IIoT Product Change Notice

The change will be applied on the ULI-213CI (BB-FOSTCDRI-SC). If you need more information or special support, please contact the corresponding PMs/AEs listed in the table below.

Affected Models	ECOM Number	Estimated Effective Date	Cut-in Implement	Change Description
ULI-213CI (BB-FOSTCDRI-SC)	ECOM-196593	12/30/2022	Running Change	Update name plate and UL File Number

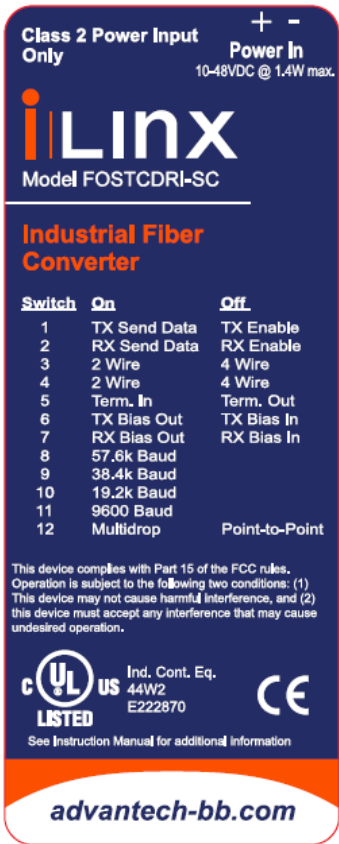
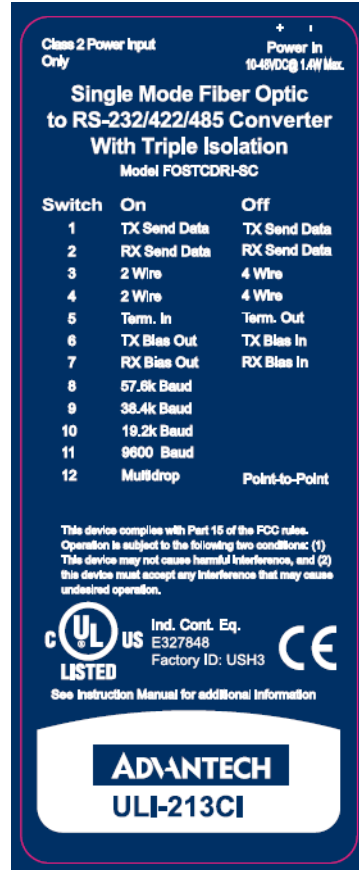
- Reason for the Change:** Branding and UL File Number change.
- Affected Products:** ULI-213CI (BB-FOSTCDRI-SC)
- Impact on Application:** No change to form, fit, or function.

Item	Impact
Impact on Mechanical Design	No
Impact on Software Compatibility	No
Impact on Environment Characteristics	No
Impact on System Certifications	Yes – UL File Number is changing from E222870 to E327848
Physical Outlook Change	Yes
Ordering P/N Change	No
Cut-in Implement	Component Running Change

Affected Models	Current Component	New Component	Category	Outlook Difference	Reason																																							
ULI-213CI BB-FOSTCDRI-SC	20BB250-10708-00	1990038137T010	Label	<p>Old name plate</p>  <p>Class 2 Power Input Only + - Power In 10-48VDC @ 1.4W max.</p> <p>iLinx Model FOSTCDRI-SC</p> <p>Industrial Fiber Converter</p>

New name plate
